ON-SITE SEWAGE DISPOSAL SYSTEM HOWARD COUNTY HEALTH DEPARTMENT BUREAU OF ENVIRONMENTAL HEALTH

SUBDIVISION: Harless Manor, Phase I LOT NUMBER: 15

RE: Adjustment to Existing Sewage Disposal Easement
Harless Manor Lot 15, Monticello Drive

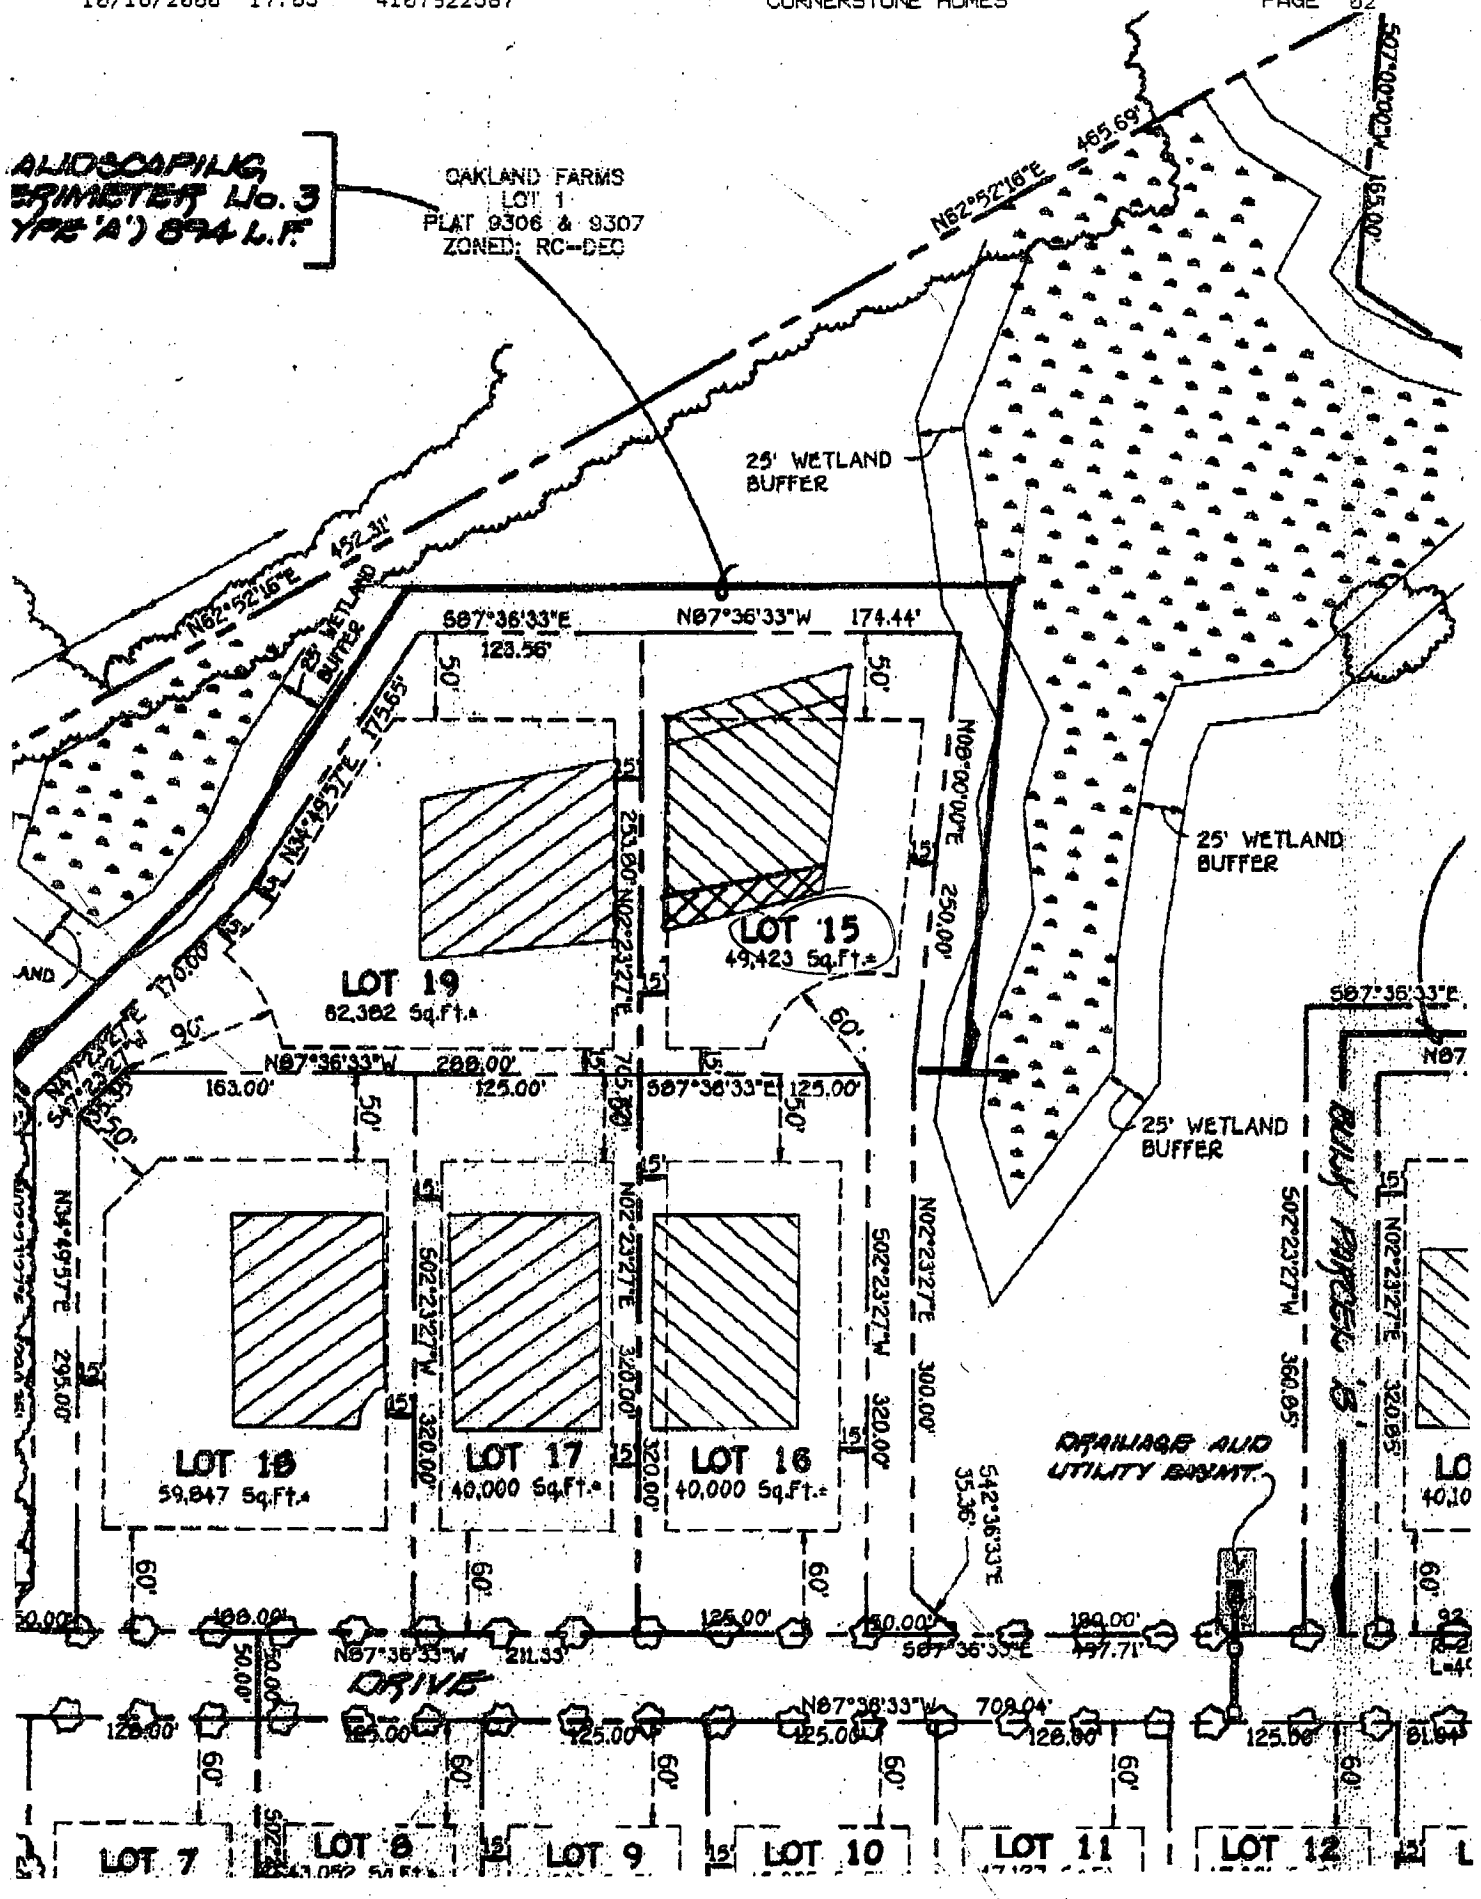
Per our conversation on Friday, I am enclosing a copy of the layout for Harless Manor lot 15 (formerly lot 2B). As we previously discussed, we hope to have the ability to move the septic field back approximately fifteen feet towards the rear of the property; see revised location on attached plan.

10/17/00 Unable to process request - unable to locate file - Need a site stake out to see if soil sensor testing would be needed before recommending approval of change request. RP 10/17/00

Harless Manor
Lot 15

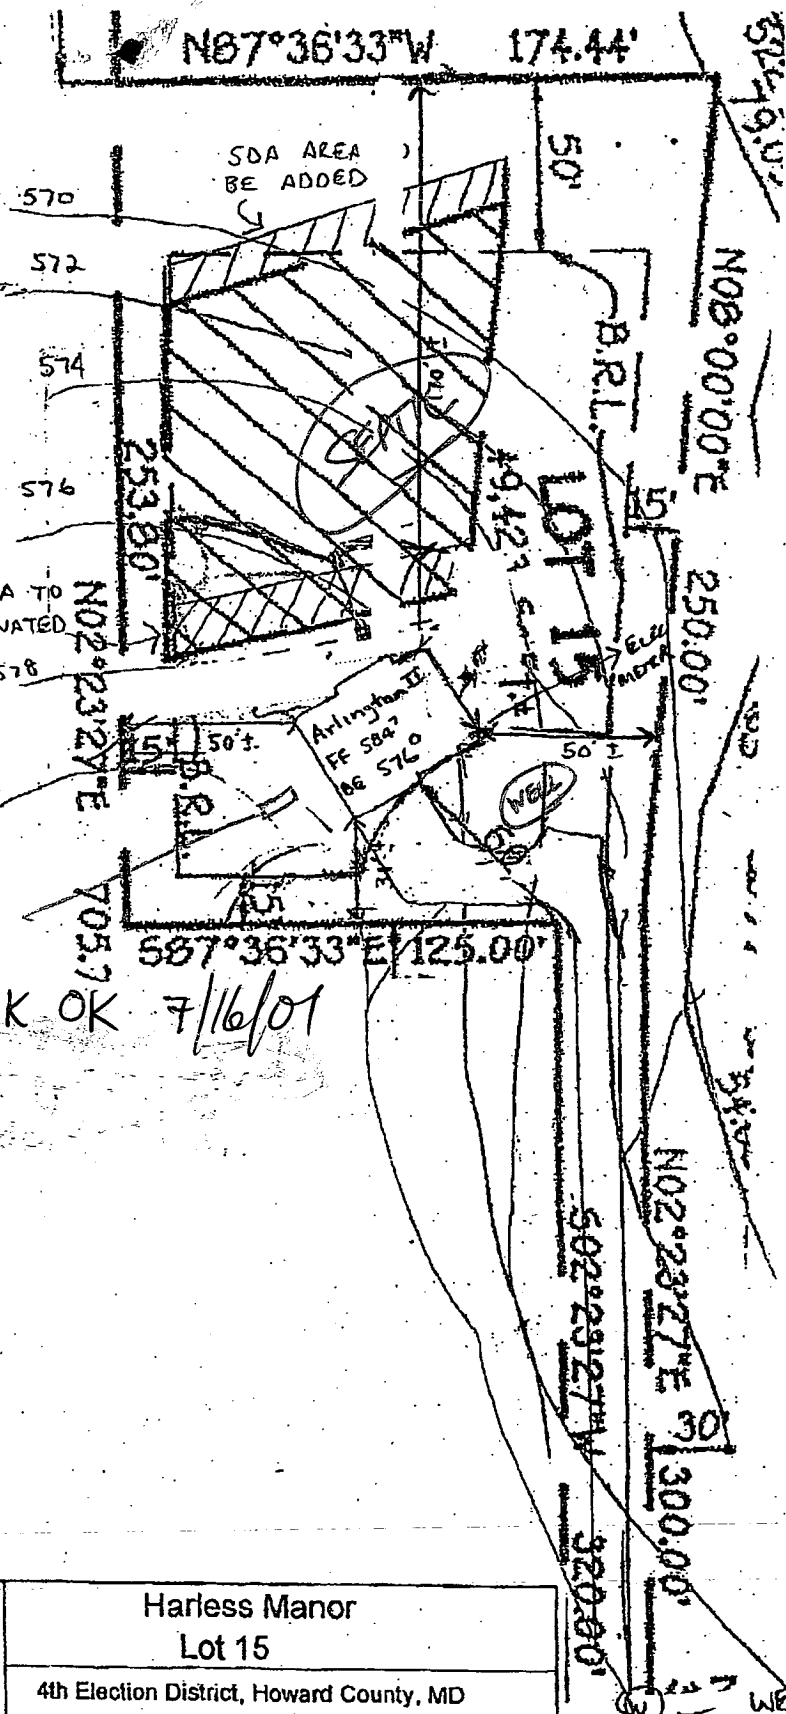
NEEDS EJECTOR
PIT

PREPARE
TANK

TANK OK 7/16/01
